REMARKS / ARGUMENTS

Amendments to the Drawings

FIG. 1

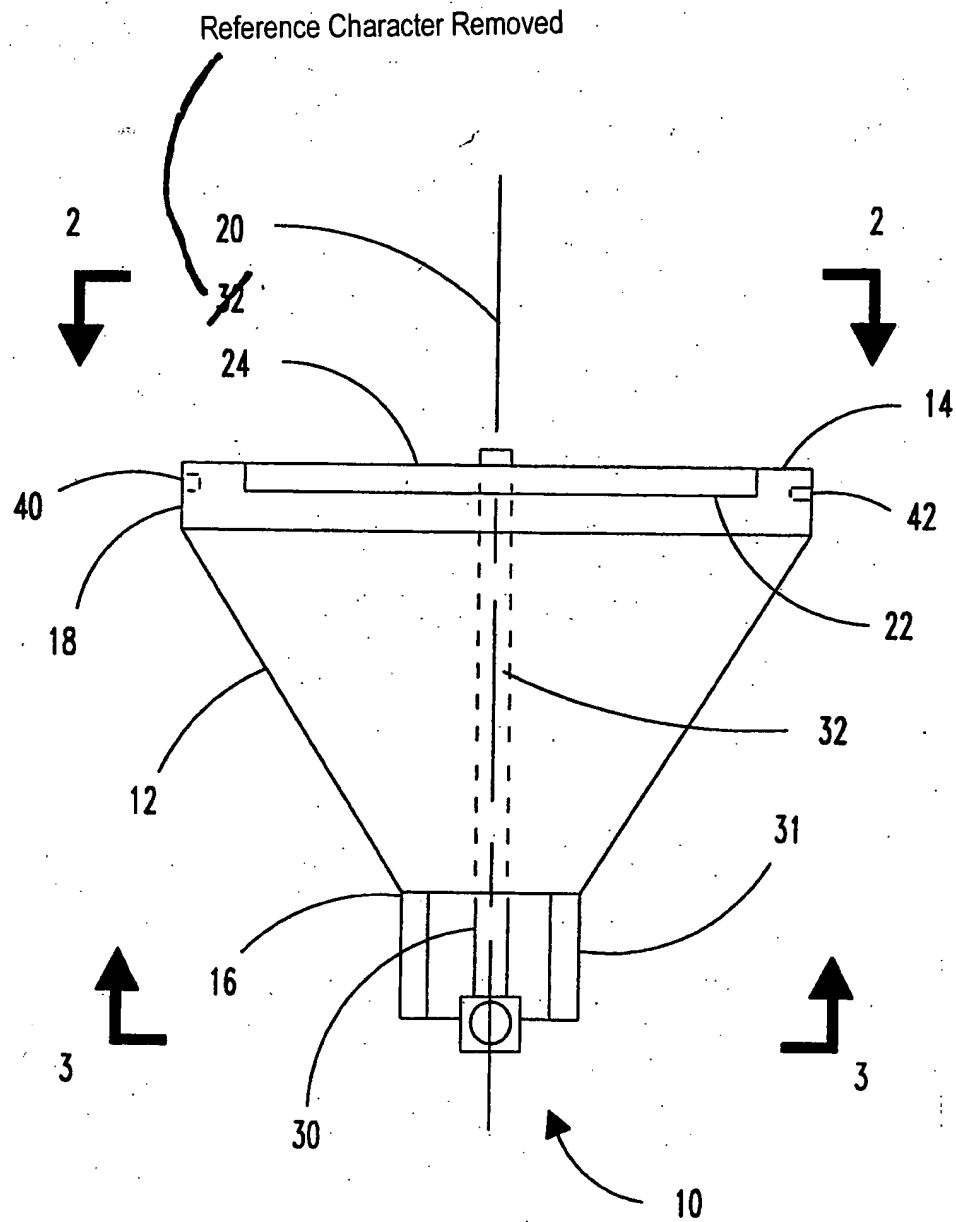
In the Office Action, the drawings were objected to because reference character "32" between "20" and "24" should be deleted in FIG. 1. Corrected drawing sheets in compliance with 37 CFR

In the Office Action, the drawings were objected to because reference character "32" between "20" and "24" should be deleted in FIG. 1. In response, FIG. 1 has been amended to delete reference character "32" between "20" and "24". It is submitted

The attached sheet of drawings includes changes to FIGS. 1 and 4. In FIG. 1, reference character "32" has been removed. In FIG. 4, reference character "(54)" has been changed to "(55)".

FIG. 4

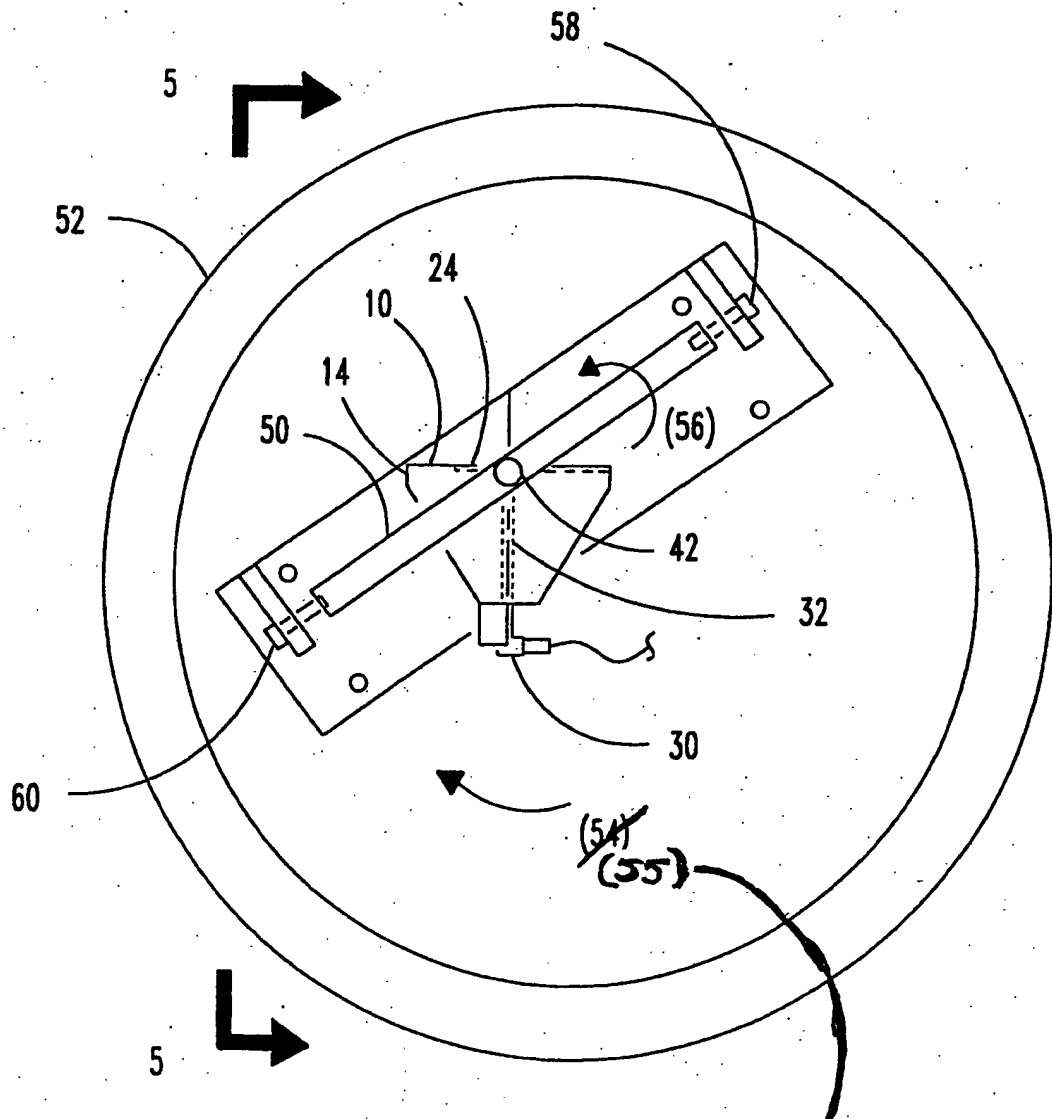
In the Office Action, the drawings were objected to as failing to comply with 37 CFR 1.84(p)(4) because reference character "54" has been used to designate both a tow body and gravity(See Page 11). Corrected drawing sheets in compliance with 37 CFR 1.121(d) are required in reply to the Office action to avoid abandonment of the application. Any amended replacement drawing sheet should include all of the figures appearing on the immediate prior version of the sheet, even if only one figure is being amended. Each drawing sheet submitted after the filing date of an application must be labeled in the top margin as either "Replacement Sheet" or "New Sheet" pursuant to 37 CFR 1.121(d). If the changes are not accepted by the examiner, the applicant will be notified and informed on any required corrective action in the next Office action. The objection to the drawings will not be held in abeyance.

In the Office Action, the drawings were objected to as failing to comply with 37 CFR 1.84(p)(4) because reference character "54" has been used to designate both a tow body and gravity (See Page 11). In response, FIG. 4 and the corresponding text in the specification has been amended to change reference character "(54)" to "(55)" to designate the swinging arc by gravity. It is submitted that amended changes to FIG. 4 and the corresponding text in the specification do not add new matter and that the objection of the Office Action is resolved.

Reference Character Changed
